**DIVISION OF RATEPAYER ADVOCATES
CALIFORNIA PUBLIC UTILITIES COMMISSION**

**DRA REPORT ON THE
PIPELINE SAFETY ENHANCEMENT PLAN OF
PACIFIC GAS AND ELECTRIC COMPANY**

Implementation Plan Analysis and Recommendations

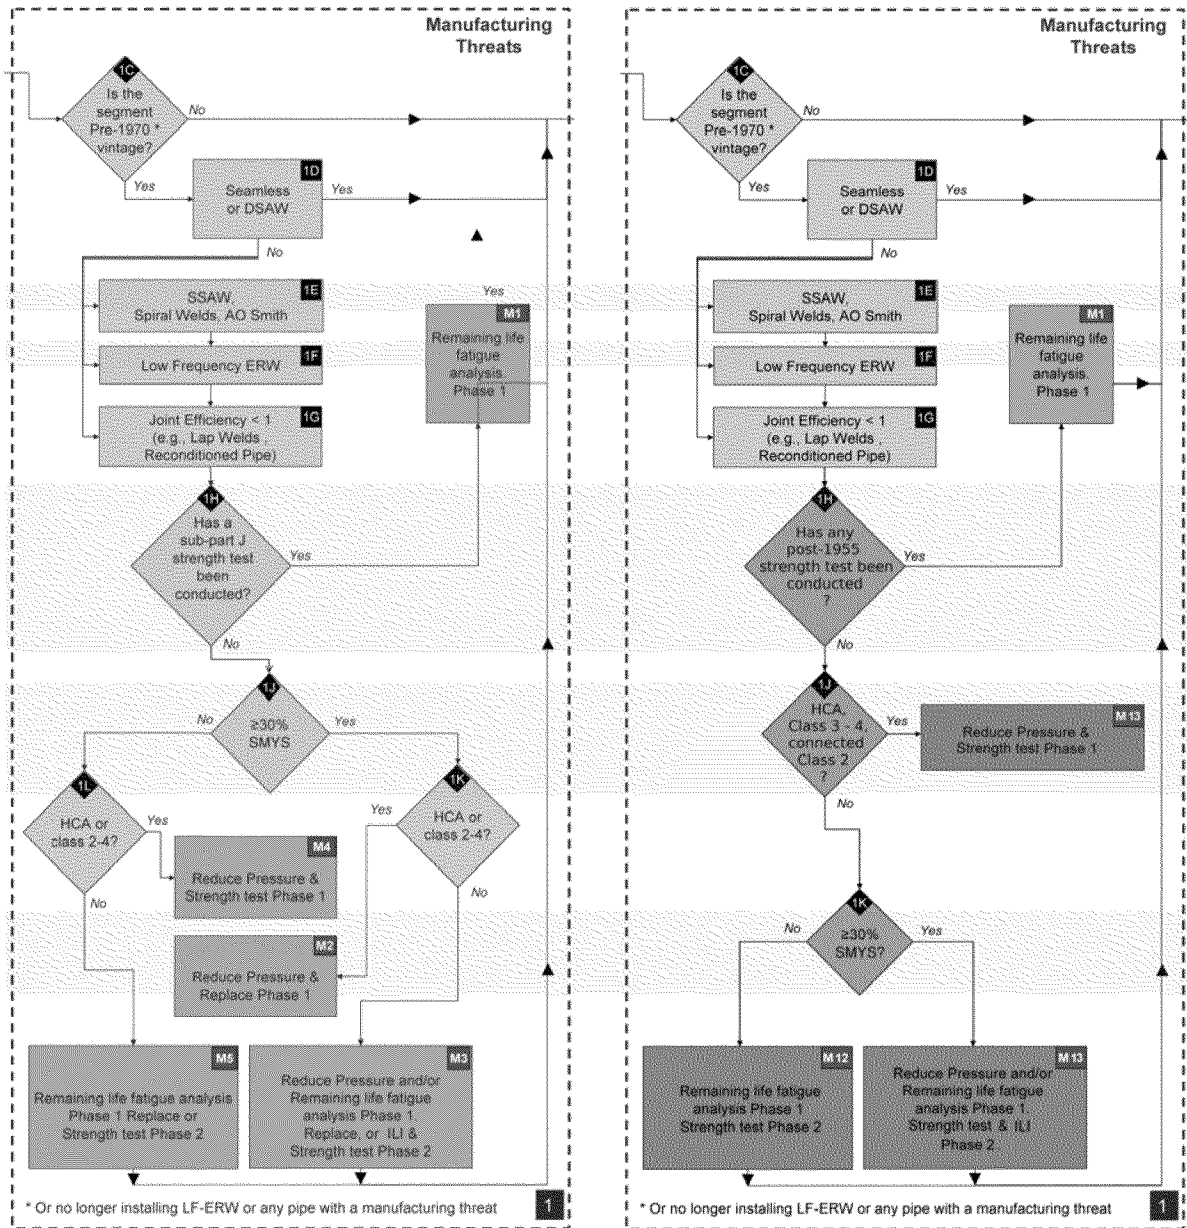
8 Subpart J testing was incorrectly used to evaluate potential pipe joint fabrication
9 threats. Because documentation of a Subpart J test should not be a deciding point for
10 taking action on a fabrication or construction threat, BEAR recommends to remove
11 Subpart J testing as a decision criteria from the Fabrication and Construction portion, part
12 2, portion of the Decision Tree.

20 Figures 1a, 1b, and 1c show the three parts of the decision tree, with both the
21 original PG&E and modified BEAR decision points and outcomes.

Figure 1a: Decision Tree Comparison – Manufacturing Threats

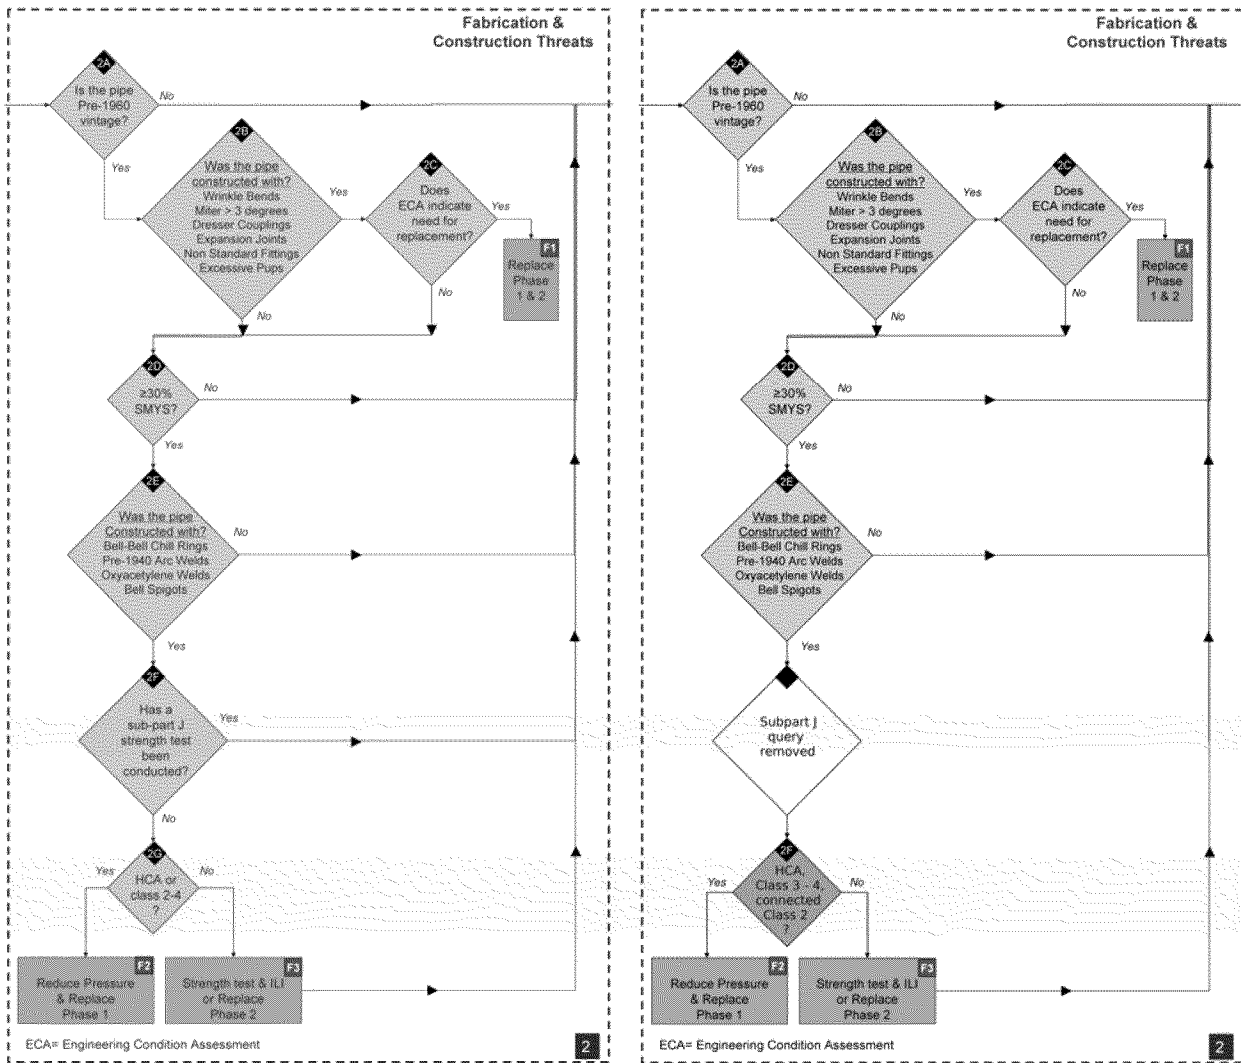
2 In addition to the above classification prioritization, additional improvement in
3 Phase 1 prioritization comes from two other modifications within the Manufacturing
4 Threats branch. First is a greater reliance on fatigue analysis and second is using a wider
5 range of strength tests as input into the fatigue analysis.

6 Rather than query whether a Subpart J test has been conducted (at 1H,
7 Manufacturing Threats), the query should include any post-1955 strength test, which was
8 when the ASA B31.1.8 standard included test pressures based on population density. The
9 strength test results and pressure history can be put to immediate use in a fatigue analysis,
10 the results of which would guide further action. By doing so, Phase 1 strength testing
11 will focus on pipes with almost a completely unknown potential for flaw size. Phase 2
12 will address updating all tests to Subpart J standards.

13 In addition, it should also be noted that replacement as a default Phase 1 action has
14 been removed from the Manufacturing Threats branch. Replacement may still occur as
15 the result of a strength test, fatigue analysis, or a Phase 2 decision. With these
16 modifications, manufacturing threats will lead to a Phase 1 strength test if the pipe
17 segment has no post-1955 test results and is in a HCA, Class 3-4, or connected Class 2
18 area.

13 BEAR recommends that, with the exception of fabrication and construction threats
14 (joints between segments), the first action to mitigate risk should be a Subpart J test, in-
15 line inspection (ILI), and/or a remaining life fatigue analysis.

Figure 1b: Decision Tree Comparison – Fabrication Threats

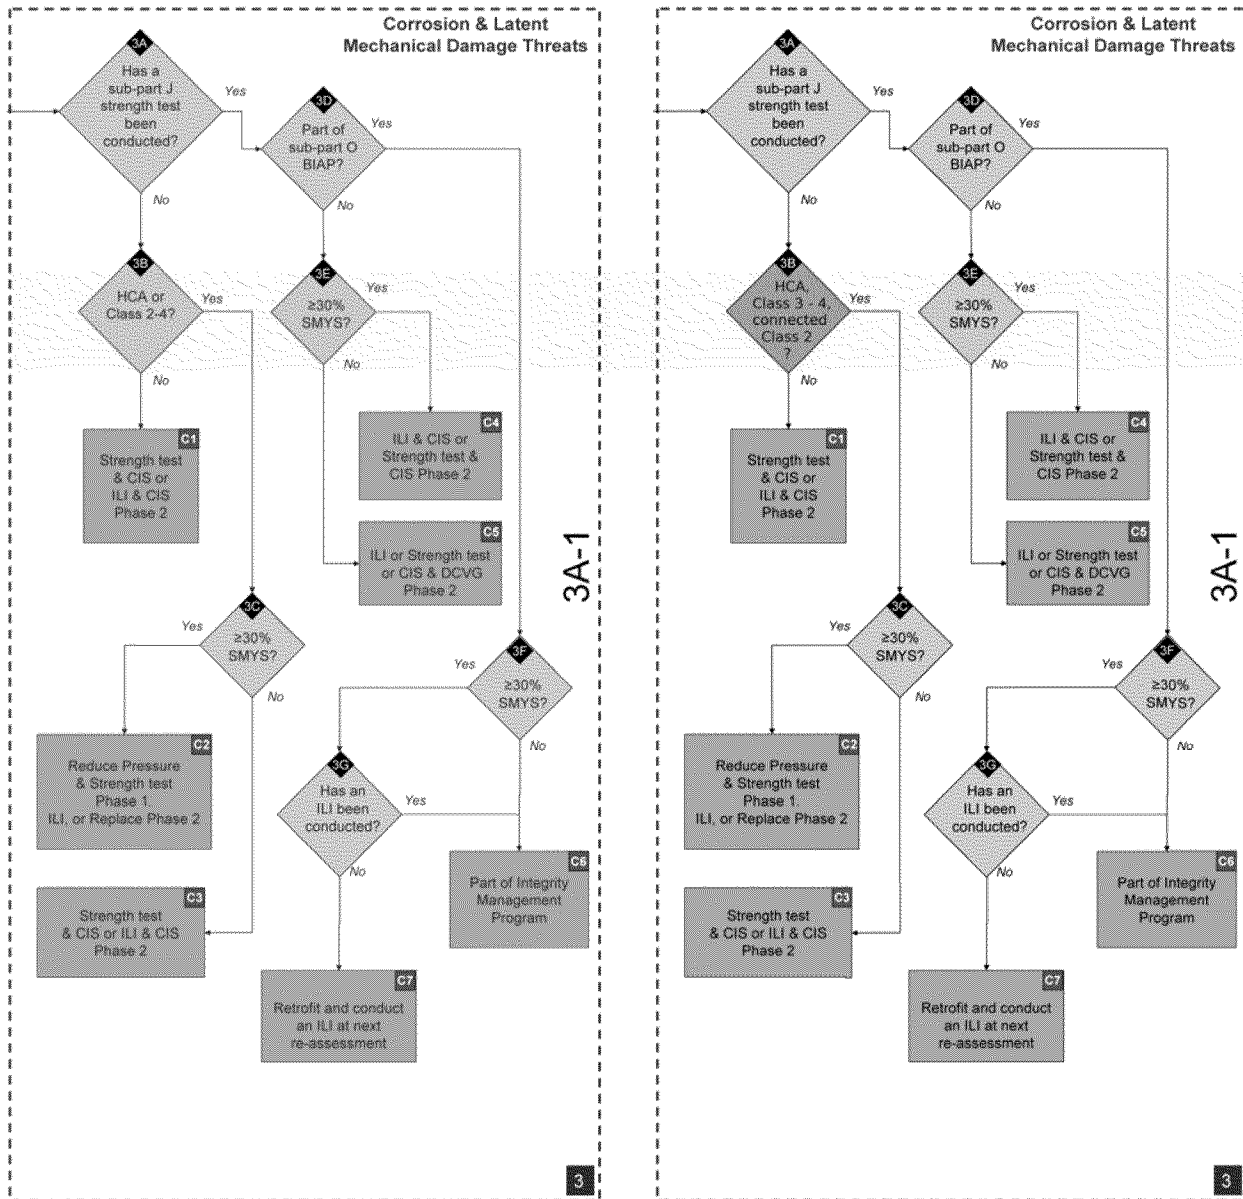
3 Two queries in the Fabrication & Construction Threats branch raise concern. First
4 is query 2C, which asks if an Engineering Condition Assessment (ECA) indicates a need
5 for replacement. Details of what this assessment includes were not available, except that
6 “Any feature whose condition is not proven satisfactory for service or would jeopardize
7 the success of a subsequent In-Line Inspection will be removed from service”¹⁷. PG&E
8 verbally confirmed that the ECA had not yet been formulated¹⁸. Until that time, BEAR
9 recommends that an assessment include the potential for soil movement (seismic or
10 otherwise).

11 Next is the use of a Subpart J query at 2F. BEAR is in agreement with Kiefner &
12 Associates, Inc that the pipe features listed in the Fabrication & Construction Threats
13 branch are primarily susceptible to failure from axial rather than hoop stresses¹⁹.
14 Consequently, a hydrostatic test is not well suited for evaluating the condition of these
15 features. For this reason, BEAR recommends removing this Subpart J query.

16 This modification presents a lower risk than the original Decision Tree. More
17 segments will be flagged for Phase 1 replacement than in the original Decision Tree, and
18 all of these additional segments will be in high priority areas. It should be noted that
19 action F3 still includes a strength test, but it is the ILI that is most important.
